AGENDA

TOWN OF BROOKFIELD
ARCHITECTURAL REVIEW COMMITTEE MINUTES
JANUARY 10, 2024

TOWN OF BROOKFIELD ARCHITECTURAL REVIEW COMMITTEE STAFF REPORT

RE: ARC Staff Report – February Agenda Items

Project: **The Glow Dr/Channel Letters**

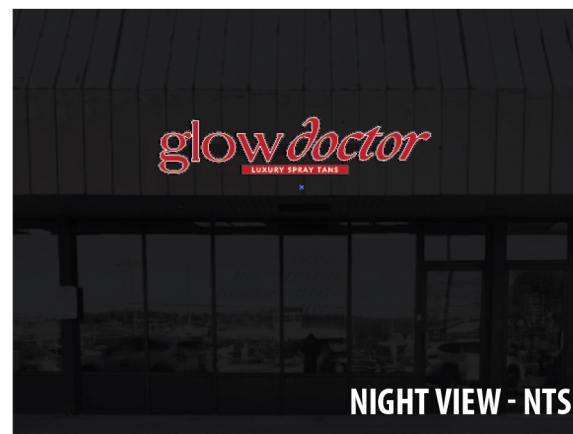
- Requesting to add an internally illuminated wall mounted sign above their storefront.
- Proposed sign is approximately 23.5 square feet in size, which does not meet the 13.3 square feet allowed by the Town's code (occupant has 16.7 lineal feet of storefront).
 - This does not meet typical sign area requirement, but the Committee may approve exceptions.
- Proposed sign will extend 12" from the building, which meets the Town's code.
- Proposed sign appears proportional to existing adjacent signs.

Hyderabad House

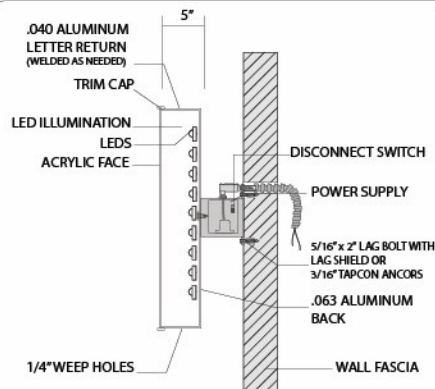
- Requesting to remove and replace an existing wall sign.
- Proposed sign has a red background, with “Hyderabad House” printed in white letters and includes the business’ logo.
- Proposed sign is 68.5 square feet, which does not meet the 48.0 square feet allowed by the Town’s code (occupant has 60.0 lineal feet of storefront).
 - This does not meet typical sign area requirement, but the Committee may approve exceptions.
- Proposed sign will extend approximately 12” from the building, which meets the Town’s code.
- Proposed sign appears proportional to existing sign it will replace and existing adjacent signs.

Photo Survey of Proposed
view only; not to scale

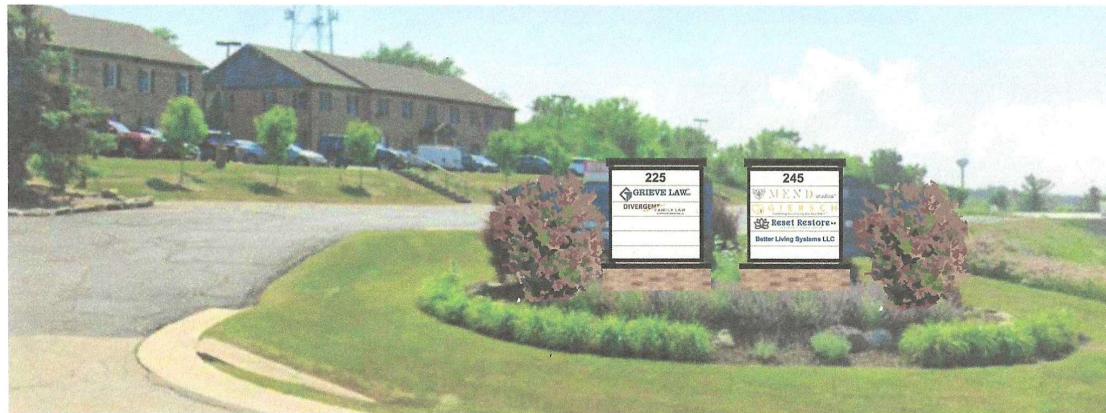
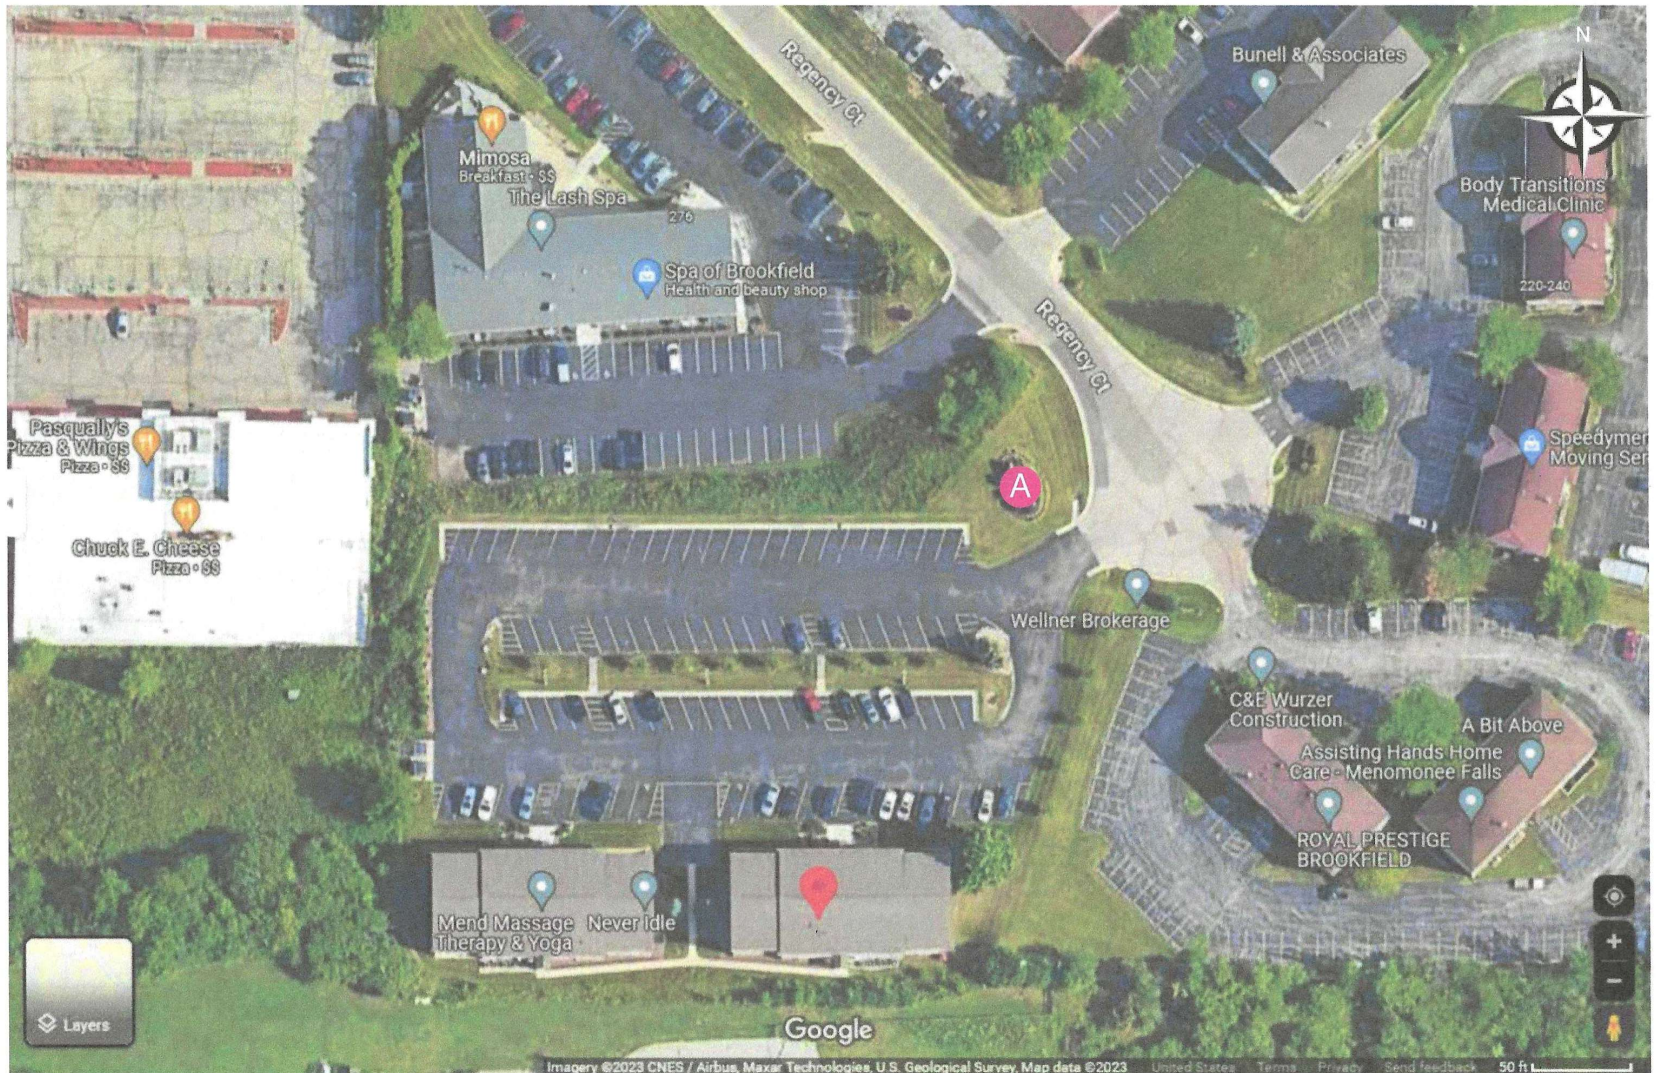
- There are currently two existing freestanding signs at this location that displays a multi-tenant panel sign for 225 & 245 Regency Ct.
- The proposed monument signs show a 2’ masonry base and the total height from grade is 7’ tall.

- Both signs show 5 tenant panel signs, with some panels currently vacant.
- Both sign areas are approximately 25 square feet each.
- The signs indicate the address but does not label the name of the development which is a requirement in the sign code.

- The development name is required according to the Town’s sign code requirements.
- The existing 245 Regency Ct sign appears to be extend beyond the property line and the applicant is proposing to replace the existing signs in the same location. There is typically a 5’ setback for signs.

- The setback does not meet the Town’s sign code requirements.
 - The Committee could make an exception since the sign would be located in the same location.

- The signs will be internally illuminated. The sign code requires that the “background of internally illuminated, cabinet-type sign faces shall be opaque or a color other than white”. The plans currently shows a white background.

- The background color does not meet the Town’s sign code requirements.
 - An updated sign rendering showing the night view should be required, if approved.

- No dimensions were provided for the address numerals but I estimate the numerals are smaller than 6 inches. The code requires eight inches minimum height for address numerals.

- The text height does not appear to meet the Town’s sign code requirements.

SHEET NUMBER
C100

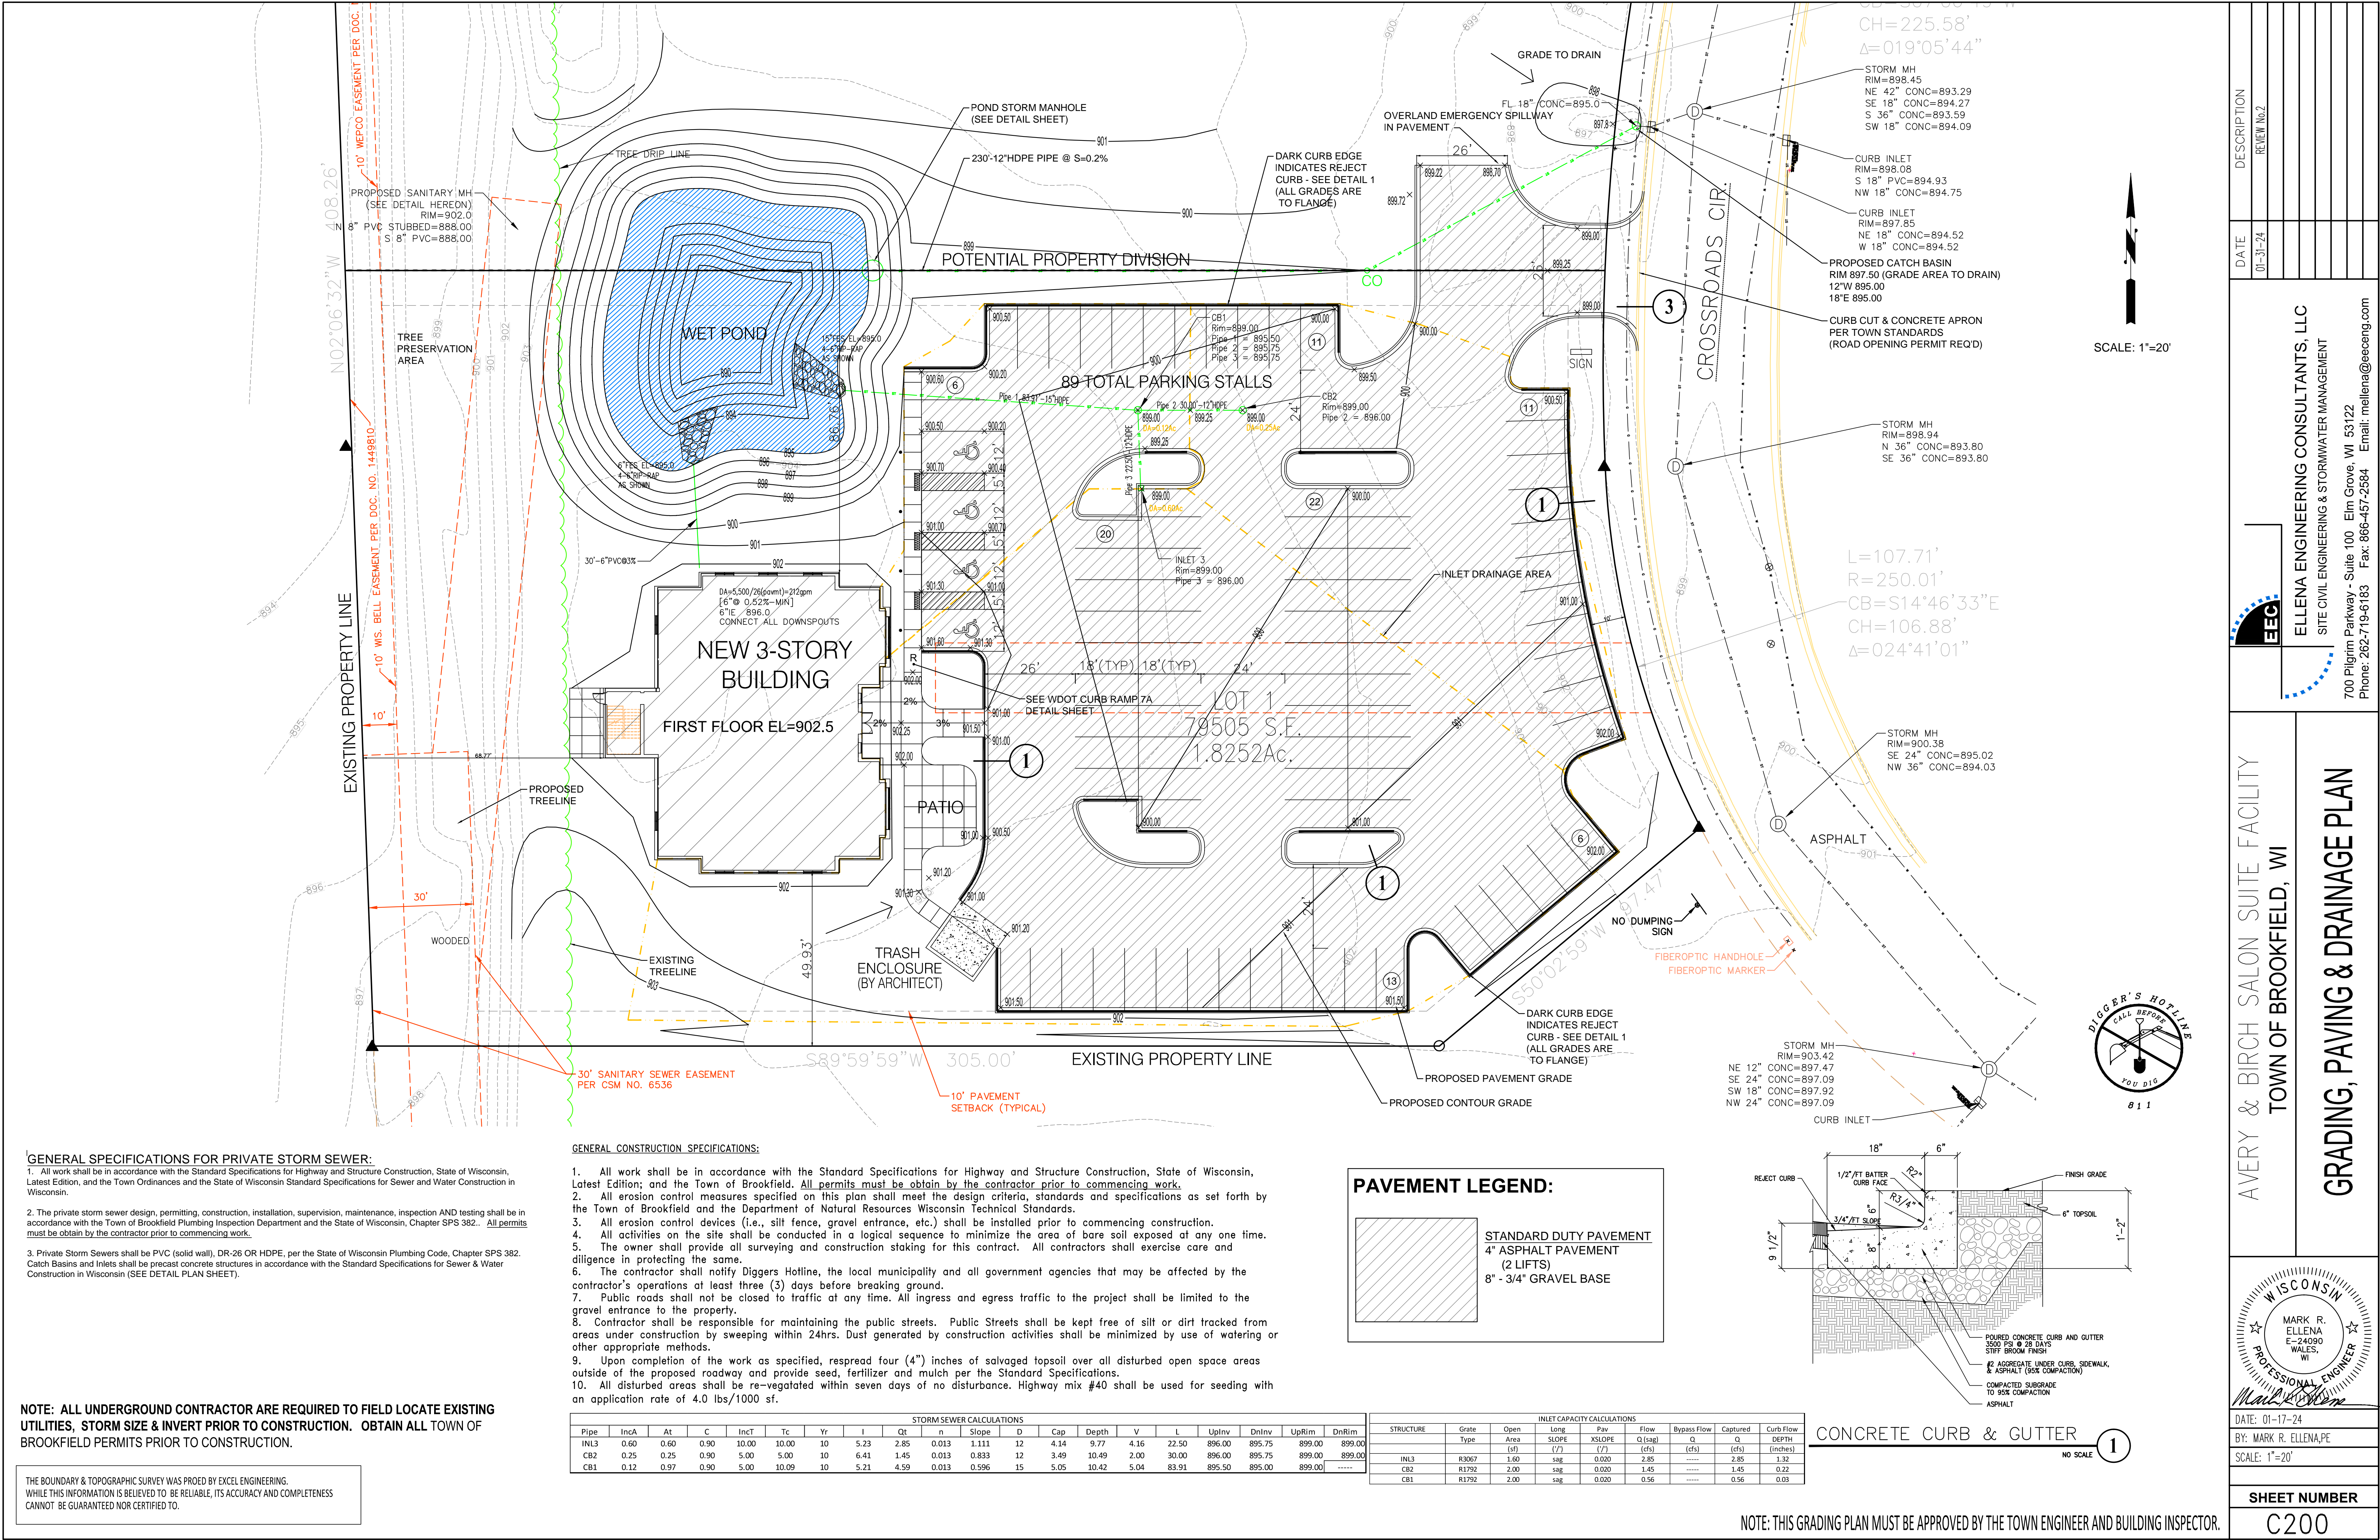
- Proposed structure = 16,500 total square foot three-story facility with salon suites. Approximately 5,500 square feet each floor.
- Approximately 89 parking stalls currently proposed, including 4 handicap stalls.

- The proposed use is likely considered a personal service use, which requires one space per 200 square feet of gross floor area, plus one space per employee for the work shift with the largest number of employees.

- There appears to be an adequate amount of parking provided on-site.
 - The proposed site plan shows a drive access connection to the future lot to the north.

- Proposed setbacks:
 - Front = 210+’
 - Side = 87’ north and 50’ south
 - Rear = 69’
 - All building setbacks will meet code requirements.
 - The pavement setback along the Crossroads Circle right-of-way appears to meet the 10’ requirement.

- Sum total of floor area
 - Proposed = 20.7% of lot area.
 - Required = No less than 6,000sf or 15% of the lot area, whichever is less. Shall not exceed 50% of lot area.

- Requirement is met.
- No building height dimensions were provided but the building will likely meet the 45’ height requirement.
- There are single-family residences directly to the west of the subject property, but only one of the adjacent parcels is zoned residential. The applicant intends to keep the existing landscaping to serve as a buffer for the residential properties.

- The applicant is proposing to add a stormwater pond to the north of the building and this is proposed to serve the potential northern lot as well.
